CHANGES TO SCHEME FOR DENOTED FOR PLANNING

STAGE 4

project title	KOKO + Hope & Anchor + Bayham Place, Camden, London
drawing title	Proposed Ground Floor Plan
drawing number	AHA/KCC/GA/100
scale	1:100 (A1) 13.04.17
drawn	checked
FR/PC	DA
revision	F

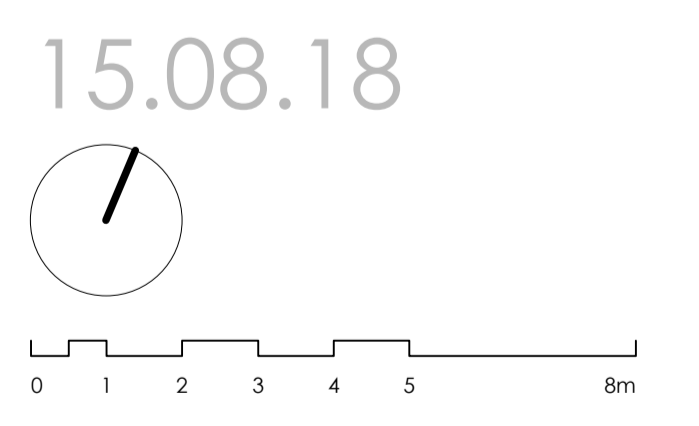
revision / date / amendments	First Issue
- / 26/01/18 /	1. Tender Addendum (1). Indication of 4 post truss fixed at stage level for integrated automatic retractable acoustic baffles and integrated lighting rig.
A / 23/03/18 /	2. Tender Addendum (2). New AHU + Attenuator over stage to be hung to existing relocated secondary beams in Flytower.
B / 12/04/18 /	- Door and window numbers updated
C / 01/06/18 /	Listed Building Application 1. Indication of 4 post truss fixed at stage level for integrated automatic retractable acoustic baffles and integrated lighting rig. 2. New AHU + Attenuator over stage to be hung to existing relocated secondary beams in Flytower.
D / 05/07/18 /	1. Updated stage fit out interior and kitchen layouts.
E / 31/07/18 /	G.5. Built out column omitted on retail side G.7. Refer to Basement drawing. WCs vents to run through to roof and boxed out as part of joinery.
F / 15/08/18 /	G.8. Ventilation grille opening below window WG-26 G.9. Basement Ventilation plant to Bin Store Colour coding added to revised drawing Rev E
